# Change Notice

# FT Series

## Change to Digital Touch Screen ITO Film

**FTAS225-57AN**  
Digital Touch Screen

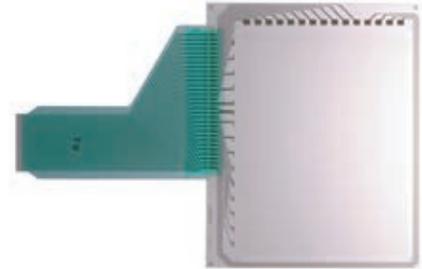
The FT Series will have a change to the ITO film for the Digital Touch Screen, part number FTAS225-57AN. The change will effect both standard and custom models. The ITO film changes are outlined below.

Changes to ITO Film for FTAS225-57AN Digital Touch Screen	
Before Change	After Change
Surface Hardness: 2H (JIS K 5600)	Surface Hardness: <b>3H (JIS K 5400)</b>
Thickness: 188µm	Thickness: <b>175µm</b>
Anti-Newton ring process: yes	Anti-Newton ring process: <b>no</b>
